# TECHNICAL SERVICE BULLETIN

## Clicking/Creaking/Clunking/Rattle/Rotational Noise From The Front Strut Area When Turning The Steering Wheel

**25-2347**

<b>Ford</b> 2021-2025 Bronco Sport	2021-2025 Bronco Sport Badlands vehicles equipped with minor feature code DWAAN (Performance suspension) 2025 Bronco Sport Sasquatch vehicles equipped with minor feature code DWAA3 (High ride suspension)
---------------------------------------	--

Figure 2

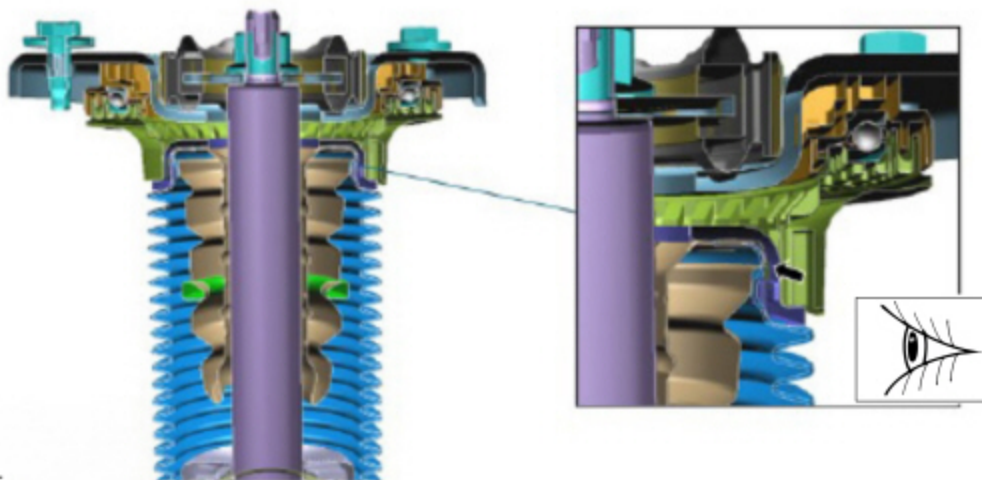
3. Install new front jounce bumpers.
4. Assemble the front strut and spring assemblies. Refer to the WSM, Section 204-01 Front Suspension > Disassembly and assembly.
  - (1). For installation, make sure the correct position and alignment between components is noted before removal. (Figure 2)

- (2). While compressing the front spring, a distinct clicking noise will be heard during the assembly of the front strut bearing, dust cover and front jounce bumper which indicates a proper assembly.
5. Reinstall the front strut and spring assemblies. Refer to the WSM, Section 204-01 Front Suspension > Removal and Installation.
